Our Ref: 18AWE02.5:NvD/JT
DoP ref: SSD 9741
NSW RFS ref: D18/8341

**Re: Lane Cove Data Centre – summary of changes for resubmission /
Addendum Bushfire Protection Assessment
1 Sirius Road, Lane Cove West**

Travers bushfire & ecology (TBE) has been requested to provide a revised bushfire assessment to address the latest amendments to the Lane Cove Data Centre scheme.

Figure 3 – Access design (new scheme)
 (Source: Travers bushfire & ecology, dated 20 January 2020)

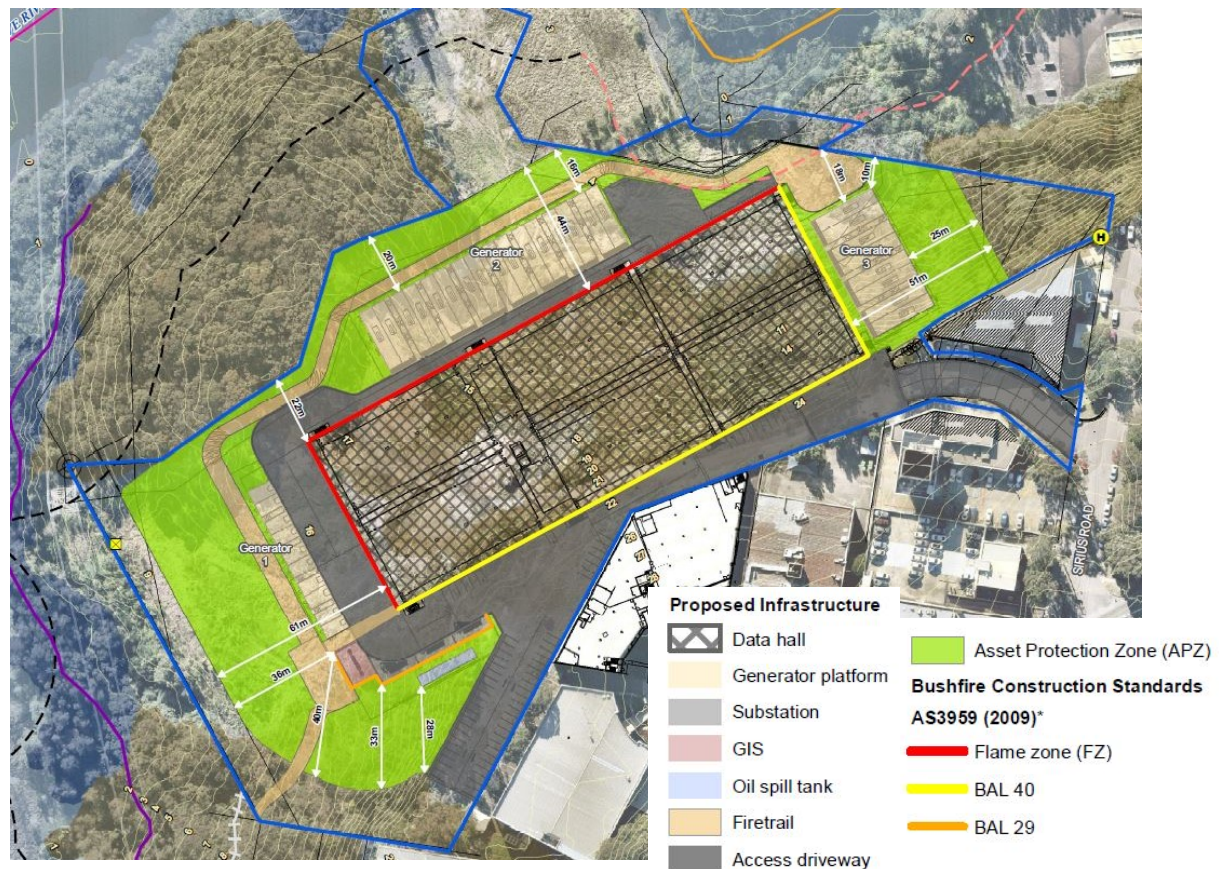
Property access remains largely unchanged, with the western portion of the road now located on Level 3 of the generator platform, with two (2) generator platforms above. The changes in road design are depicted in Figures 2 & 3 below.

As depicted above, the revised scheme maintains compliance with the NSW RFS conditions for private roads. Turning heads have been designed to ensure Category 1 fire tankers can undertake a minimum three (3) point maneuver.

The changes to the fire trail design are outlined in Figures 1 & 2 above. The general alignment of the fire trail in the north remains the same, however the fire trail now links with the internal road beneath Generator Platform 2. The private access road now provides access to the eastern boundary of the development.

- A minimum vertical clearance of 4m is provided to any overhanging obstruction (tree branches or the building itself).
- A passing bay will be provided every 200m (20m long by 3m wide (making a minimum trafficable width of 7m).
- Turning heads will be designed to ensure Category 1 fire tankers can undertake a three (3) point maneuver.

Figure 4 – Level 1 (fuel tank location)
(Source: Greenbox, dated 15 January 2020)

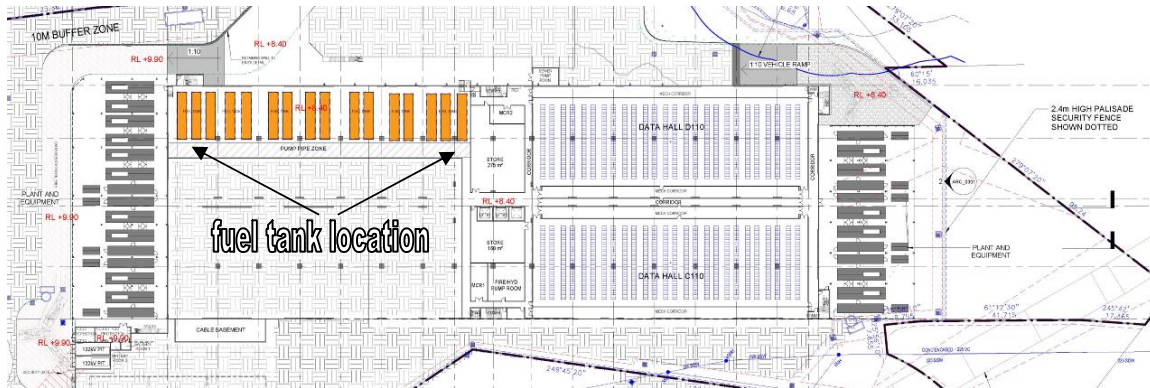
The diesel fuel storage originally located externally as approved under SSD-9741; has now been re-located within the data centre building on level 1. These will consist of sixteen (16) individual steel tanks located on the northern side of level 1 (refer Figure 4). The diesel store will be bunded to contain any potential fuel leaks or spills. Based on the new location, steel tanks will revert to single walled with leak detection provided to the room itself. The room will be 4-hour fire rated.

As a result, the proposed relocation of the fuel tanks within the building will not contribute to the bushfire risk posed to emergency services personnel.

TITLE
Schedule 1 - Bushfire Protection Measures
Document Path: N:\GIS STORAGE\N Drive\18AWE02_SiriusRd_LaneCoveWest\MXD\18AWE02_BF001.mxd

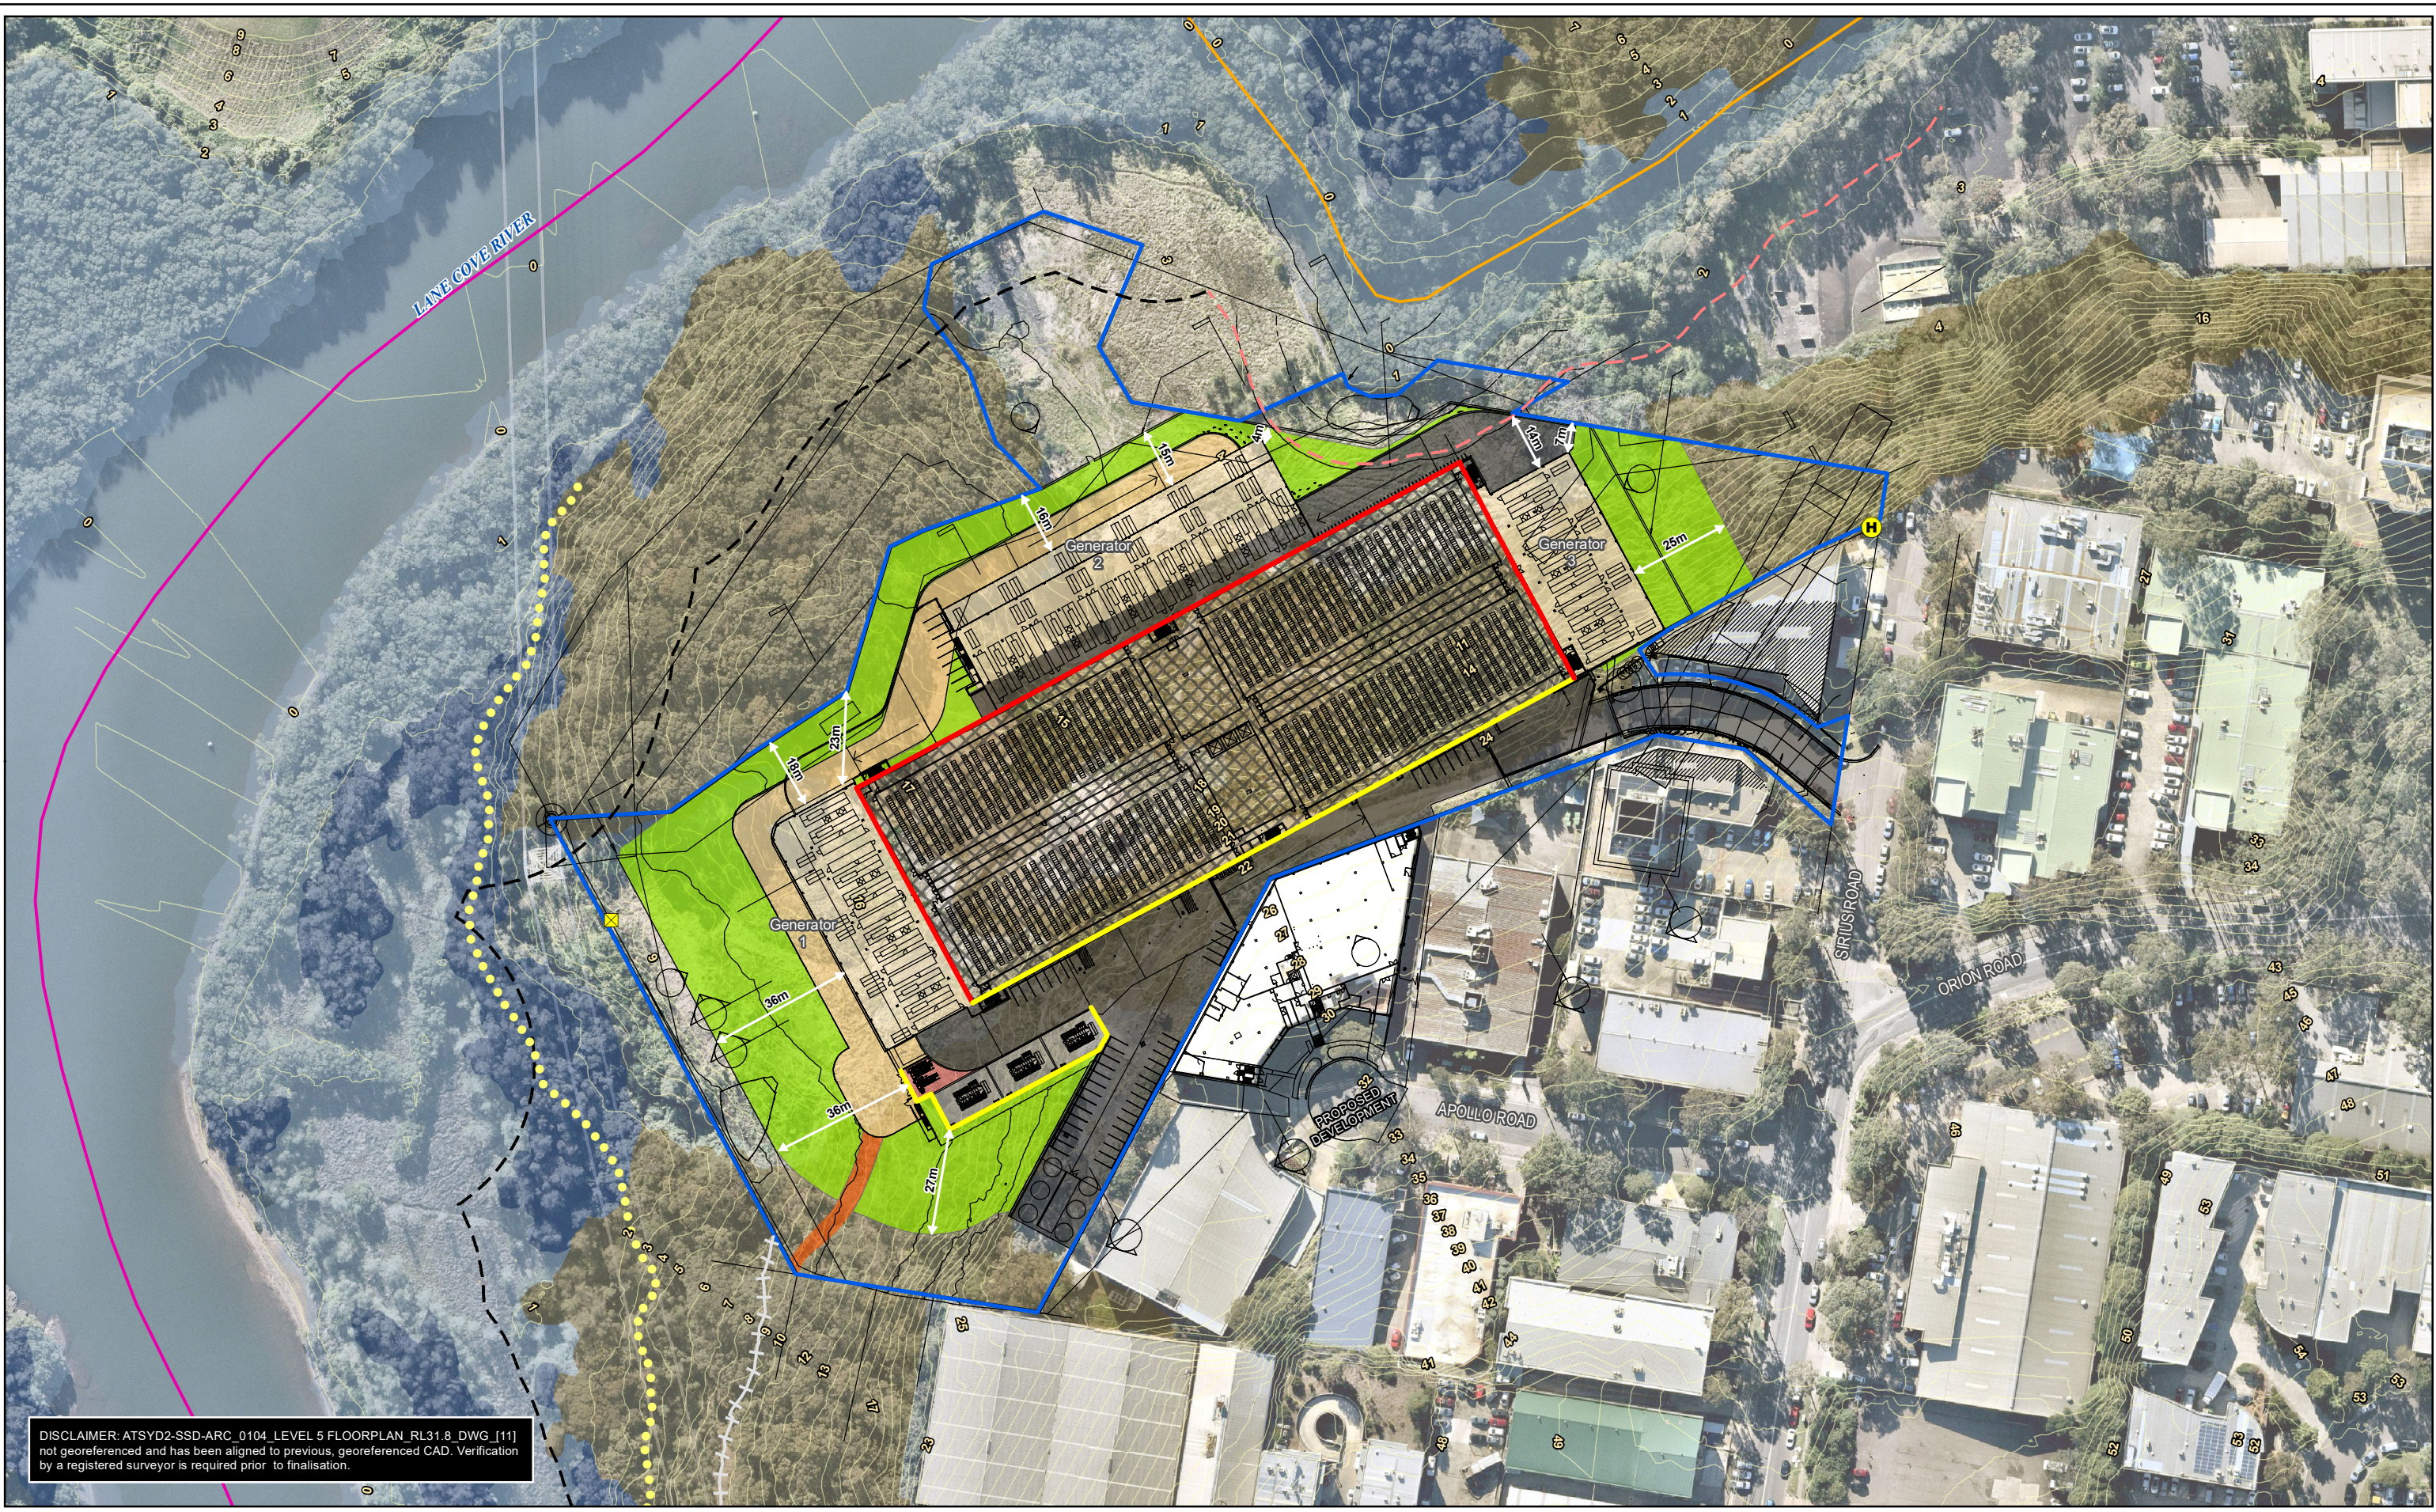
The revised scheme maintains the same data centre building footprint and height. However, the external generator platforms have been amended and the footprint area has increased slightly. For the most part, the generators are set back further from the bushfire hazard, they do however extend closer to the bushfire hazard in some instances (i.e. Generator Platforms 1 & 3 – closer to the northern site boundary, Generator Platform 2 – closer to the east). In addition, the substation location has been amended slightly and has been moved further south by a distance of 6m.

As a result, the APZ dimension has been amended to reflect the new substation and platform locations / extent as depicted in Schedule 1 – Bushfire Protection Measures attached and as follows.

Aspect	Vegetation formation within 140m of development	Effective slope of land	Setback provided previously (metres)	Revised APZ dimensions (metres)
Substation				
South	Forest	0-5 ^{0D}	33	27
West	Forested wetland	5-10 ^{0D}	36	36
North & east	Managed land / industrial development	N/A	>100	>100
Generator Platform 1				
West	Forested wetland	5-10 ^{0D}	36	36
North	Forest	5-10 ^{0D}	25	18 – 23
Generator Platform 2				
North	Forest	5-10 ^{0D}	20	16
	Short heath	0-5 ^{0D}	16	16
East	Remnant / exotic vegetation	4.5 ^{0D}	10	4
Generator Platform 3				
North	Remnant / exotic vegetation	4.5 ^{0D}	10	7-14
East	Forest	0-5 ^{0D} Cross slope	25	25

The revised scheme has resulted in a slight realignment of the substation which has resulted in a decrease in the APZ setback from 33m to 27m. The substation will be open with blast walls between each transformer. The blast walls, suspended roadway deck and APZ will provide the required shielding to prevent flame zone contact and reduce radiant heat impact to the non-enclosed substation elements.
